**SUBJECT:** **Customer Satisfaction Program 23P22 – Supplement #1**  
Certain 2024 Model Year Ranger with Ford Licensed Accessory Bed Cap Added  
Load Box Reinforcement Bracket Kit Installation

**REF:** **Customer Satisfaction Program 23P22**  
Dated February 7, 2024

**New! REASON FOR THIS SUPPLEMENT**

FIGURE 2

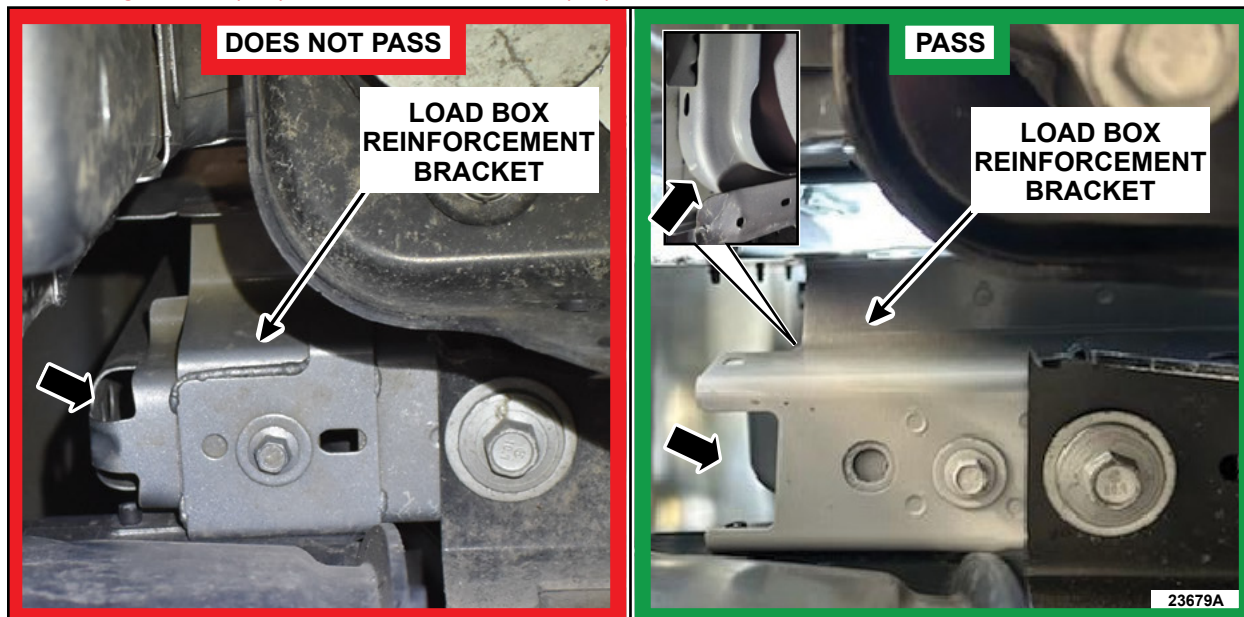
3. Inspect to see if the updated load box reinforcement bracket is present on both sides. See Figure 2.

**NOTE:** The main difference between the two brackets is the presence of holes on the corners of the bend. The updated brace has no holes and a smooth transition of the bend.

4. Install the RH and LH load box reinforcement brackets following the instructions included in the kit.
5. Submit pictures of the vehicle VIN, updated load box reinforcement brackets installed, and bed cap installed using the Mobile PTS "Report a Vehicle Concern"  
<https://m.fordtechservice.dealerconnection.com/>.
